**UNITED STATES
NUCLEAR REGULATORY COMMISSION**

**SUBJECT: PALISADES NUCLEAR PLANT - NRC SPECIAL INSPECTION TEAM (SIT)
REPORT 05000255/2012012**

Report No.: 05000255/2012012

Facility: Palisades Nuclear Plant

Palisades Rack and Pinion CRDM

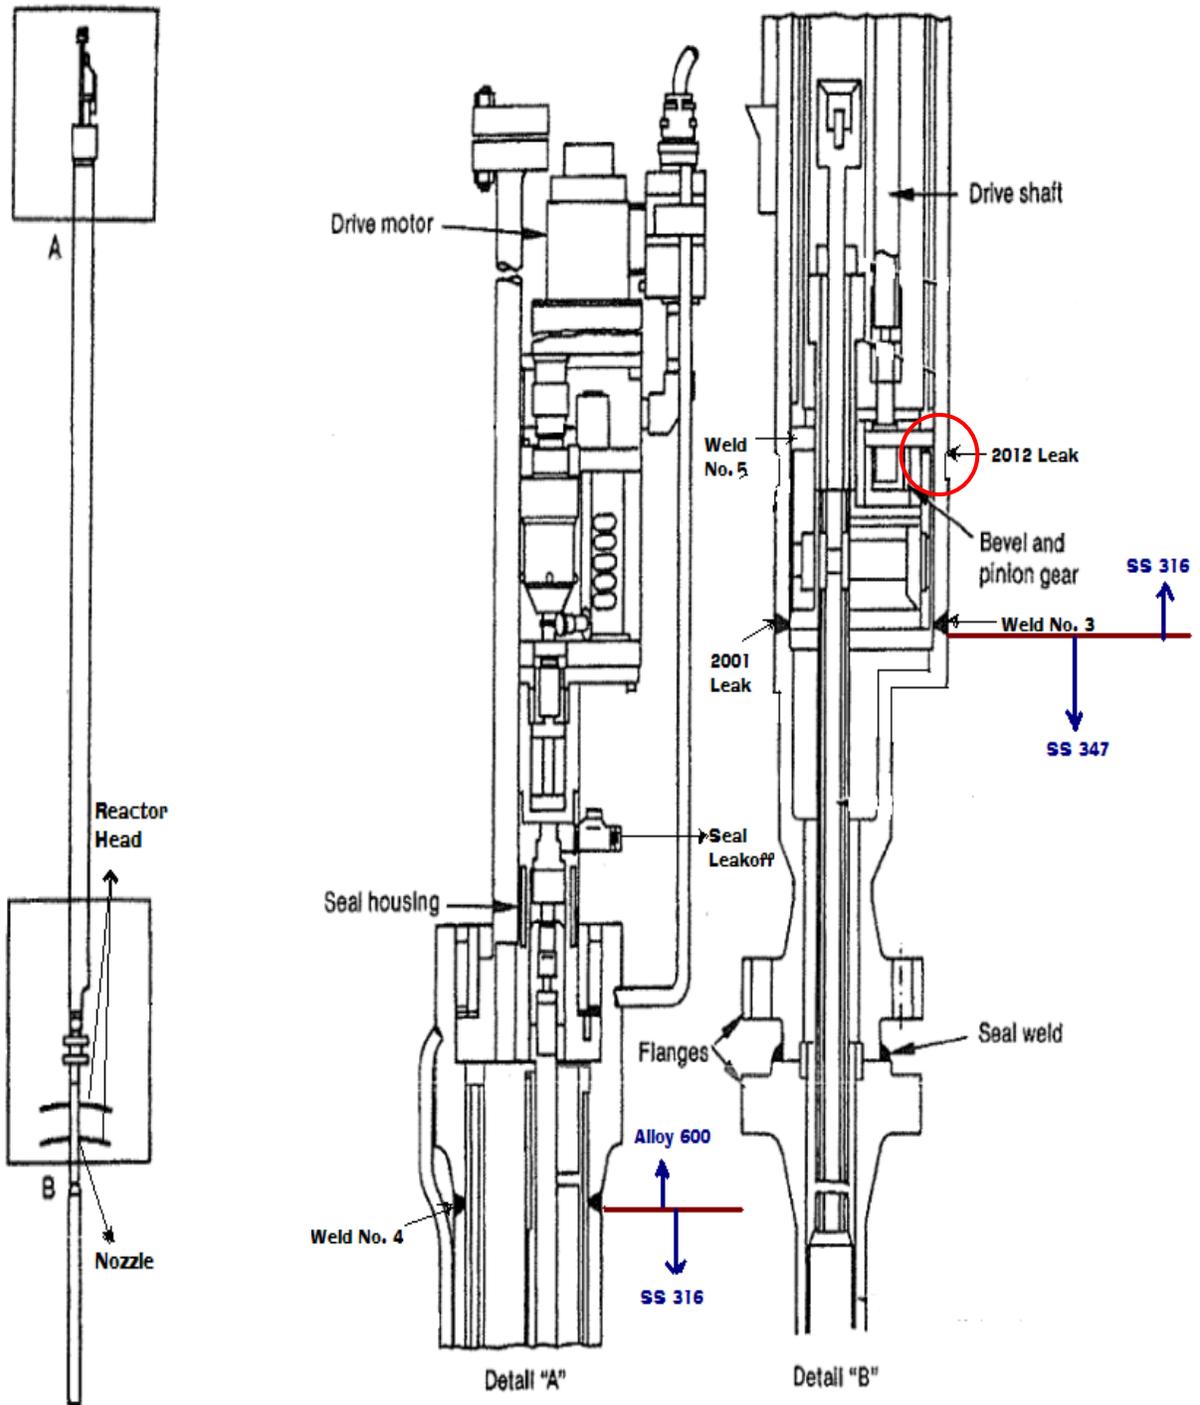
The leak was present in the lower witness band of the Type 316L stainless steel pipe section of the upper housing of CRDM-24 located above Weld No.3 (see attachment 4). Weld No.3 was a butt weld (structural weld) that joined the pipe section and the lower flange assembly of the upper housing assembly. The through-wall leak location was at the upper radius of the witness band opposite the lower taper of the internal weld build up area (non-structural weld No.5) and was axially oriented (see attachment 5). A witness band is a precisely machined area on the exterior of the pipe section used during the fabrication process as a reference for critical dimensions. A laboratory evaluation determined that the cracking in the housing of CRDM-24 was transgranular stress corrosion cracking (TGSCC) initiating from a flaw location on the inner wall, propagating outward to the outer wall. Three concurrent conditions are necessary for TGSCC to occur – namely an accumulation of tensile stresses greater than some minimum, a material that is susceptible to the cracking phenomenon, and an environment that supports cracking. An NRC inspector observed the testing done at this laboratory. In the laboratory, using a dye penetrant test, nine axial cracks were found including the crack that went through-wall. Testing done on eight additional housings (installed on the vessel head), in the same location as the cracks found on CRDM-24, found no cracks.
